Access Compliance Report

Public Rights-of-Way

(Curb Ramps)

Intersection ID: 11538	Main Street: FREEDOM_DR	Cross Street: BERRYHILL_RD	Location: S
ADA ID: B5FF870D64DA	Ramp Type: Perp	Initial Pass/Fail: Fail	Overall Compliance: No
Codes/Mitigation Info/Possible Solution		Field Measurements/Component Compliance	
		Severity Score:	10

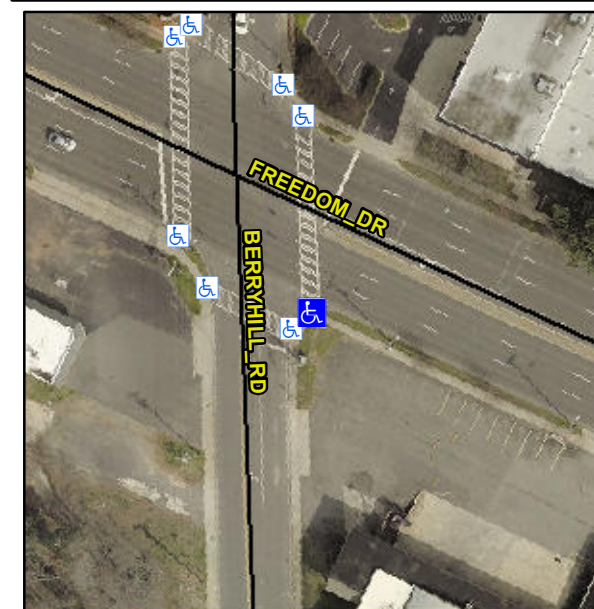
R304.5.1, R304.5.3

Compliance	Description	Data	Compliance	Description	Data
N/A	Ramp Length (in)	63.0	Yes	Ramp Slope (%)	7.4
No	Ramp Width (in)	47.5	No	Ramp XSlope (%)	2.3
N/A	Flare Type LT	N/A	N/A	Flare Type RT	N/A
N/A	Flare Slope LT (%)	N/A	N/A	Flare Slope RT (%)	N/A
N/A	Flare Traversable LT?	N/A	N/A	Flare Traversable RT?	N/A
N/A	Landing Length (in)	N/A	N/A	DWS Provided?	N/A
N/A	Landing Width (in)	N/A	N/A	DWS Contrast?	N/A
N/A	Landing Slope (%)	N/A	N/A	DWS Length (in)	N/A
N/A	Landing X Slope (%)	N/A	N/A	DWS Full Width?	N/A
N/A	Landing Curb? (Y/N)	N/A	N/A	DWS Offset (in)	N/A
N/A	Shared Landing?	N/A			
N/A	Gutter Ponding?	Yes	N/A	Gutter Slope (%)	N/A
N/A	Gutter Lip Ht (in)	N/A	N/A	Gutter X Slope (%)	N/A
N/A	Painted X Walk1?	Yes	N/A	Painted X Walk2?	N/A
	X Walk 1 Direction	To N		X Walk 2 Direction	N/A
N/A	X Walk 1 Width (in)	105.0	N/A	X Walk 2 Width (in)	N/A
	X Walk 1 Slope (%)	9.2		X Walk 2 Slope (%)	N/A
	X Walk 1 X Slope (%)	2.1		X Walk 2 X Slope (%)	N/A

N/A	Ramp inside XWalk1?	Yes	N/A	Ramp inside XWalk2?	N/A
	Road Slope (%)	N/A	N/A	Clear Space?	N/A
	Road X Slope (%)	N/A	N/A	Clear Space to XWalk (in)	N/A
N/A	Any Obstructions?	N/A	N/A	Storm Grate/Utility Hazard?	N/A
	Obstruction Type			Storm Grate/Utility Type	
		N/A			N/A
		Yes		Surface Condition? (G/P)	Good

Remove & Replace Entire Ramp.
